**E4418B-17A**

**S E R V I C E N O T E**

**Agilent E4418B EPM Average Power Meter**

**Front Panel Display Problems Caused by Power Assembly Cable**

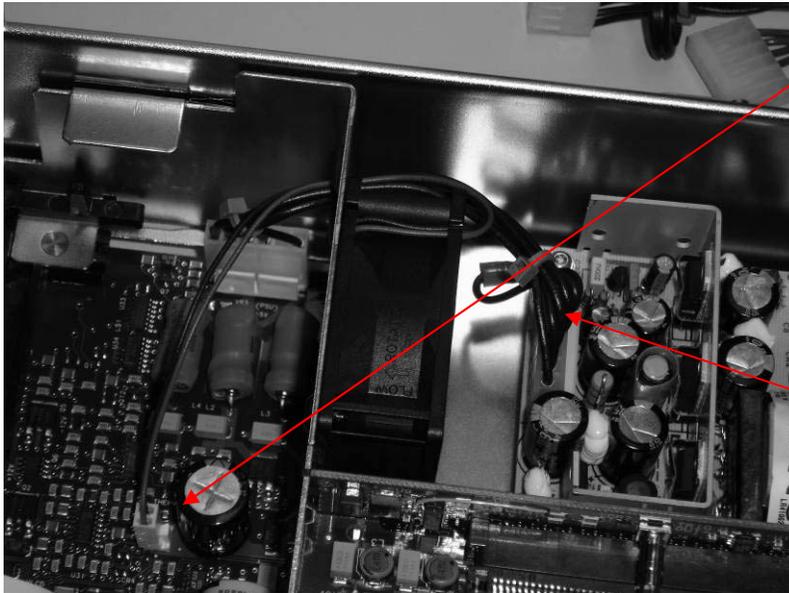
- 3) Remove fan connector and PSU cable assembly and replace with new PSU cable assembly E4418-61005. You can differentiate the cable assembly by the colors. The old cable is Black and new cable is RED.

Fan connector

PSU cable New cable is RED in color

Insert the plastic casing horizontally

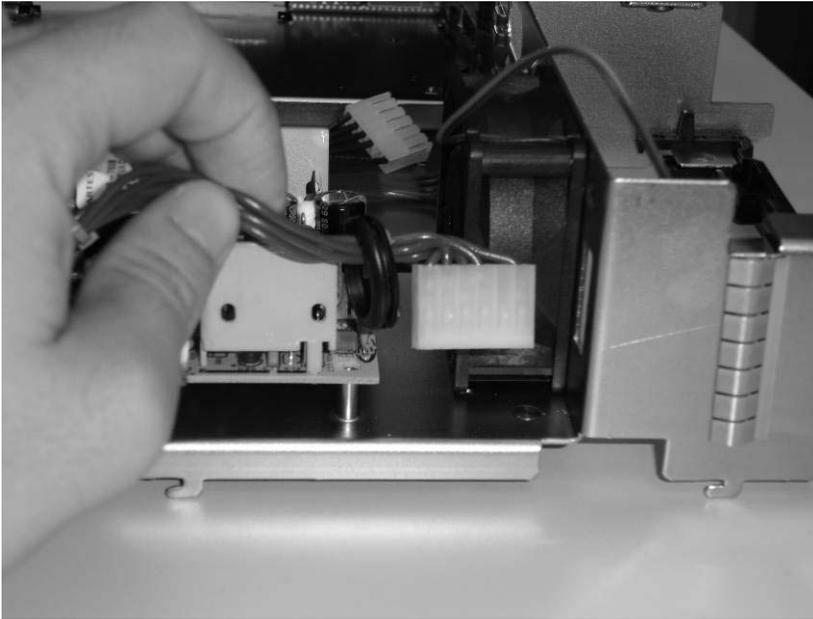
- 5) Here are some tips regarding the new cable. Since the plastic casing is slightly bigger in size, so you cannot directly pass through connector through hole. So you need to insert the cable horizontally. See illustration below.

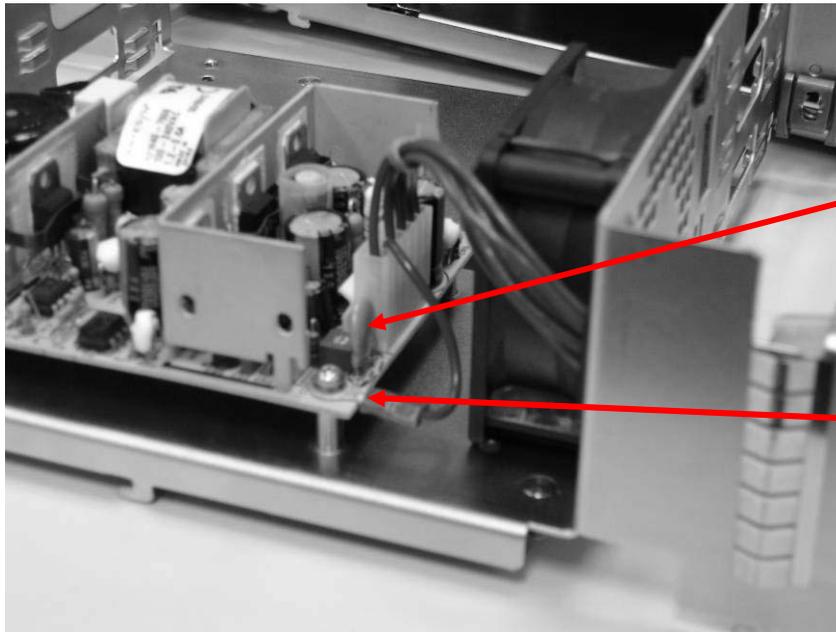
7) Photo below show different of old and new cable. The new cable is red in color whereas the old cable is black in color. The E4418-61005 has 1 ground wire.

New cable assembly

Old cable assembly

Note: If the power cable assembly is red in color, indicates that the cable already been changed. No action is needed.

Ground wire  
connected to  
PCB

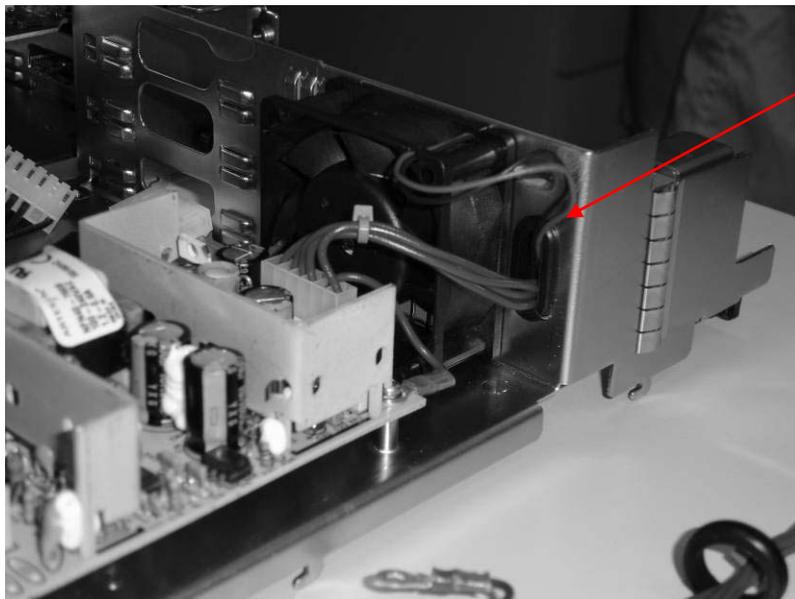
Yellow  
Capacitor.

10) This picture above shows the ground wire connection to the PCB. Please be aware that the ground connection is very close to the leg of the yellow capacitor. PLEASE DO NOT LET THE GROUND WIRE TOUCHES THE CAPASITOR'S LEG.
